AERONAUTICAL CHARTING FORUM
Charting Group
Meeting 09-02 - October 28-29, 2009
RECOMMENDATION DOCUMENT
FAA Control # 09-02-220

Subject: Multiple Intermediate Segments in Recent RNP AR (SAAAR) IAPs.

VIAD 1974 VOR/DME 12 IAP

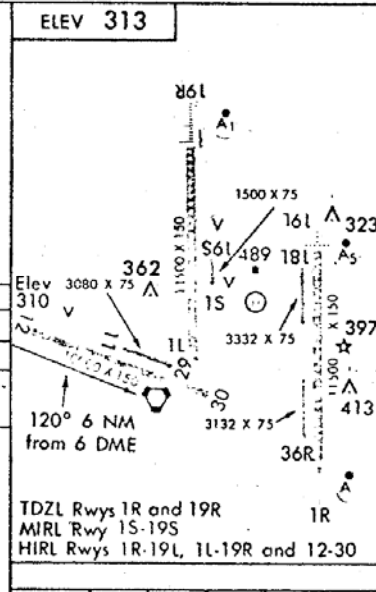
Background/Discussion: IACC and FAA specifications require the charting of the intermediate and final approach fix and segments shown in the profile view of IAP charts. The course reversal, when published, must also be shown in the profile view. (See Attachment # 1) The profile view provides an additional procedural cross-check during the critical phase of flight on an IAP when other than terminal/en route obstacle clearance is provided. This is critical for obstacle clearance in non-precision IAPs (See **F70 RNAV 18 IAP**) and for ATC compliance in multiple intercept point ILS IAPs (See **KSEA ILS 16R IAP**). In 1974 the TWA 514 CFIT accident may have been avoided had the profile view been in compliance with these IACCs specifications, which were in effect on the date of that accident (See **KIAD 1974 VOR/DME 12 IAP**).

KRIL RNP AR Z 26 IAP

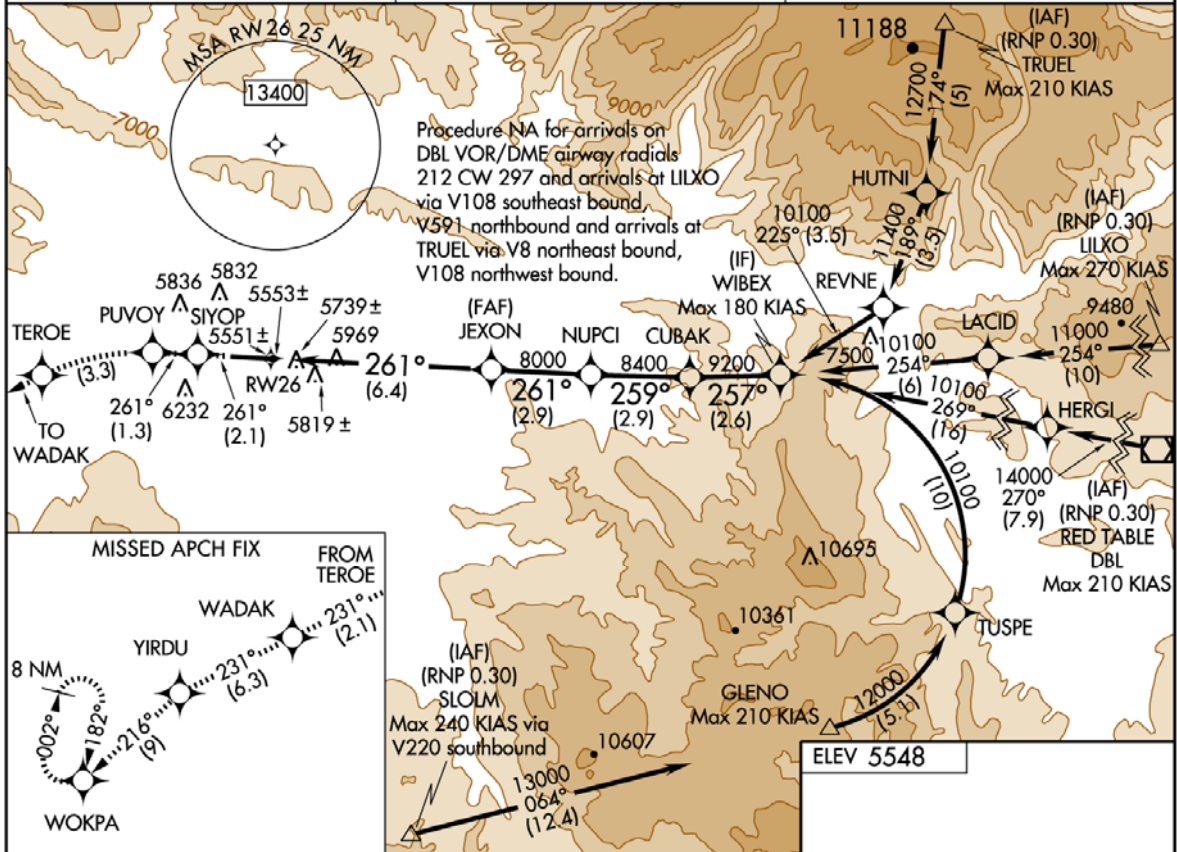
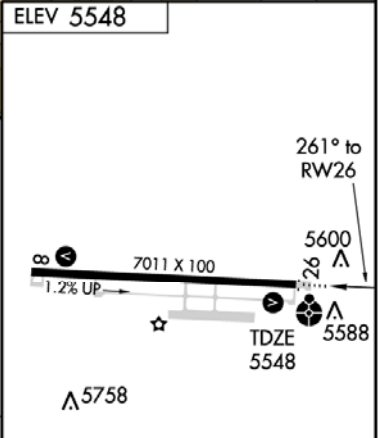
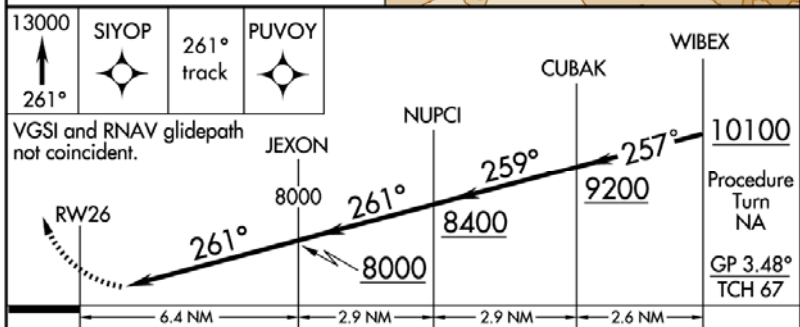
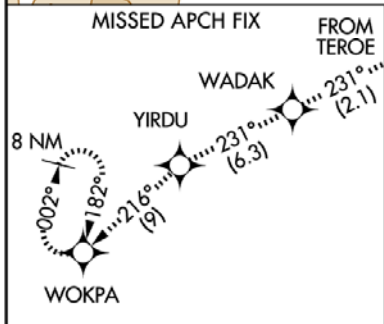
Until recently RNP AR IAP procedures (thus charts) have had one intermediate segment, thus IACC compliant profile views (See **KRIL RNP AR Z 26 IAP**). The RNP AR order, 8260.52 implies a single intermediate segment. With the recent publication of initiated RNP AR IAPs at KBOI and KRDU, the ad hoc concept of multiple intermediate segments has now appeared “*to facilitate flow control and industry use.*” (See Attachment #2, Flight Procedures Standards Waiver. Also, see **KBOI RNP AR RNP Z 28R IAP** and note foreshortened profile view)

KBOI RNP AR RNP Z 28R IAP

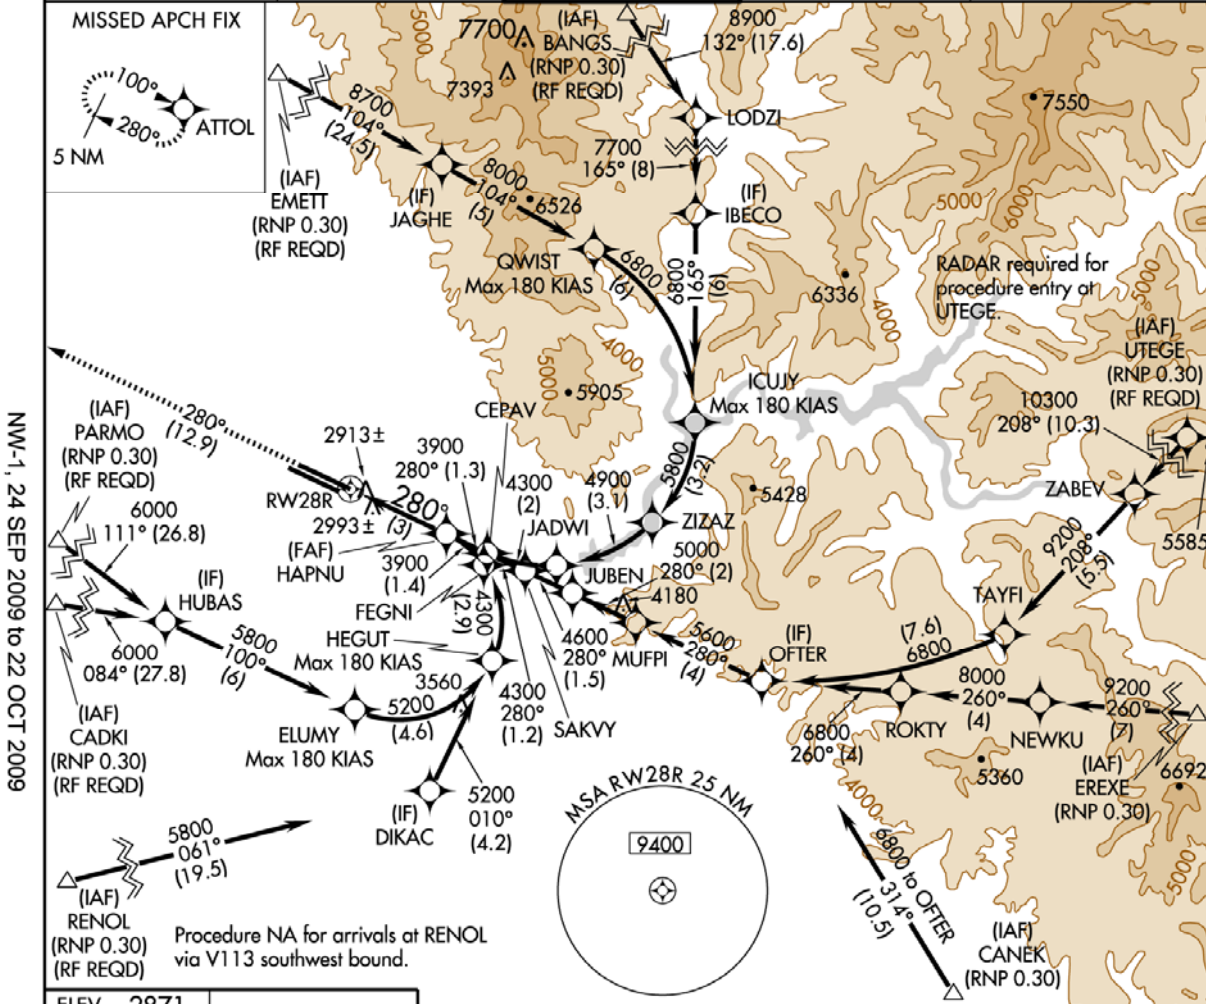
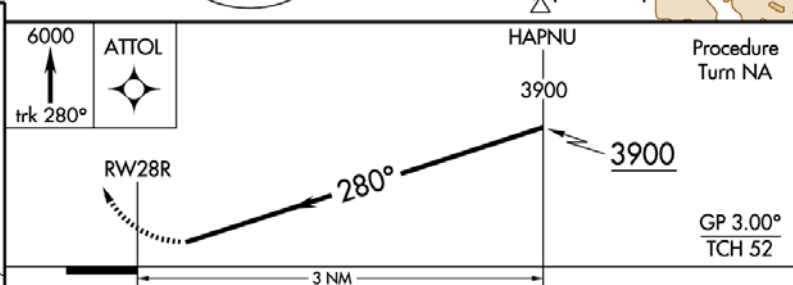
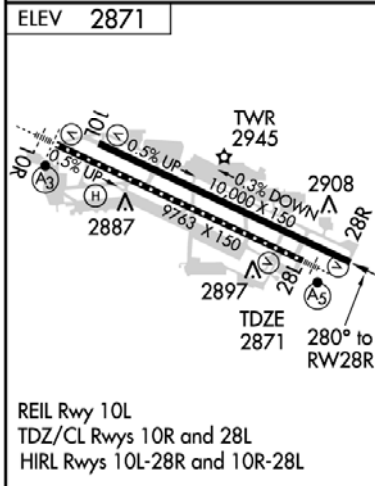
Attachment #2 illustrates what is essentially a boiler-plate waiver for each of the RNP AR IAPs at KBOI and KRDU. In NBAA’s view these waivers do not document an equivalent level of safety. Further, NBAA believes this is an incorrect use of the Flight Procedures Standards waiver process; that process is intended for waivers of TERPs criteria under TERPs, Paragraph 141. The waivers at issue are waivers of charting standards. Charting standards should not be subject to blanket waivers, rather when justified, the charting standards should be changed.

MEETING 09-02: Mr. Richard Boll, NBAA, presented the issue and suggested that until the larger issue of RNAV RNP approach chart complexity is resolved through the FAA PARC Charting WG review, the “waivered” public use RNAV AR procedures, i.e. Boise and Lewiston, should be withdrawn from public use. Instead, these public use procedures should be restricted for use only by approved operators who accept the waiver to not chart the 5 intermediate fix route segments in the profile view.

Mr. Tom Schneider, FAA/AFS420, suggested another option could be to chart only the IF route that is aligned to the FAC. This idea was not received well, and some commented that it could be misleading and might cause additional misunderstanding. In the case of Boise, only 1 of 5 routes would then be shown in the profile. Mr. Schneider then suggested that maybe a reference note could be added to the profile view to tell pilots to refer to the chart planview for IF route segment information.

LEWISTON-NEZ PERCE COUNTY (LWS)
RNAV (RNP) Z RWY 12

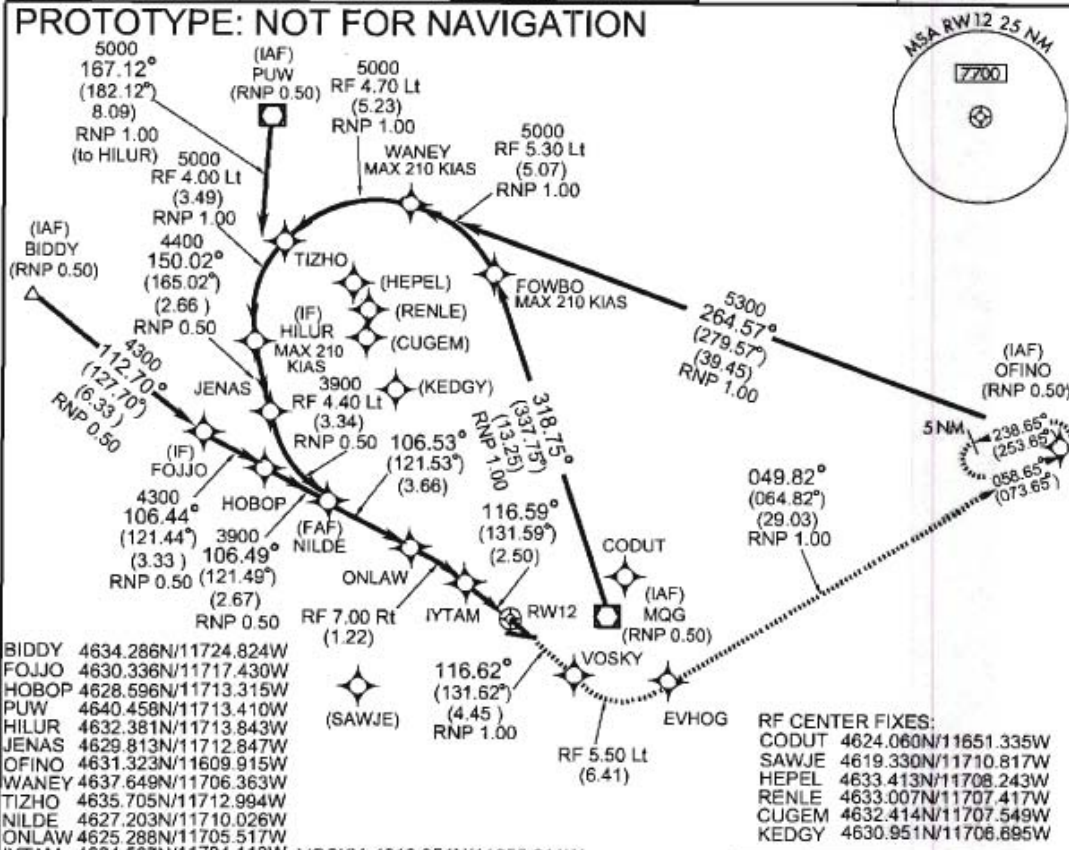
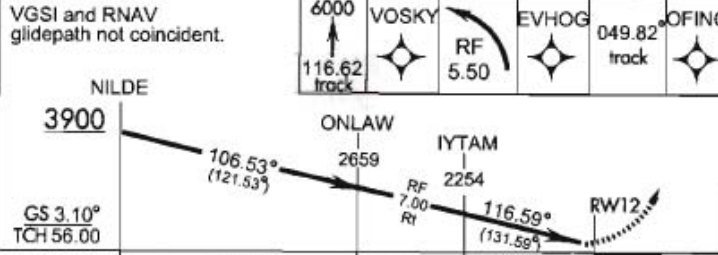
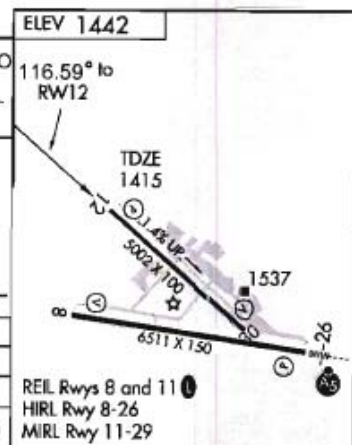
Troubling as well are deviations from these charting specifications without a waiver being documented (See KLWS RNAV (RNP) 12 & 8260-3 excerpt). This procedure is being presented for coordination without any reference to the deviation from the IACC specification and the FAA Order. Will future RNAV (RNP) AR procedures with multiple IF’s and deviating from the requirement to chart the intermediate segment in the profile view also fail to document the applicable waiver, in effect establishing a “normalization of deviance”?

11. WAIVERS OF STANDARDS		NUMBER OF WAIVERS ON FILE	
		NONE	
DATES OF APPROVAL			
PART C - REMARKS: ASOS IS ON SERVICE-A. PRECIPITOUS TERRAIN EVALUATION COMPLETE.			
<div style="border: 2px solid red; padding: 5px; display: inline-block;"> <p>What about not charting the intermediate segment in the profile view?</p> </div>			
PART D - PREPARED BY: KEITH D. SHYKES		DATE: 07/14/2009	
TITLE: AERONAUTICAL INFORMATION SPECIALIST		OFFICE: AJW-324
